**PROJECT NAME: CDBG 2<sup>ND</sup> STREET ADA SIDEWALK IMPROVEMENTS**

**BID NUMBER: 2025-013**

**Addendum No. 2**  
**February 20, 2026**

C - 101

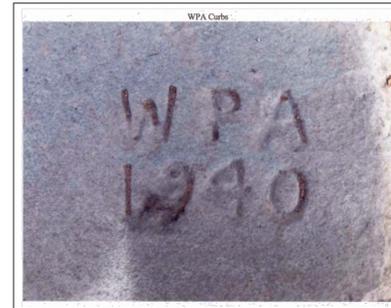
- 9. General Note 36 says that the fillets are incidental to the drive pads. Is the SY of the fillets included in the drive pad quantities?
  - A. Yes the Drive pad quantity amount was increased to account for the concrete fillets.
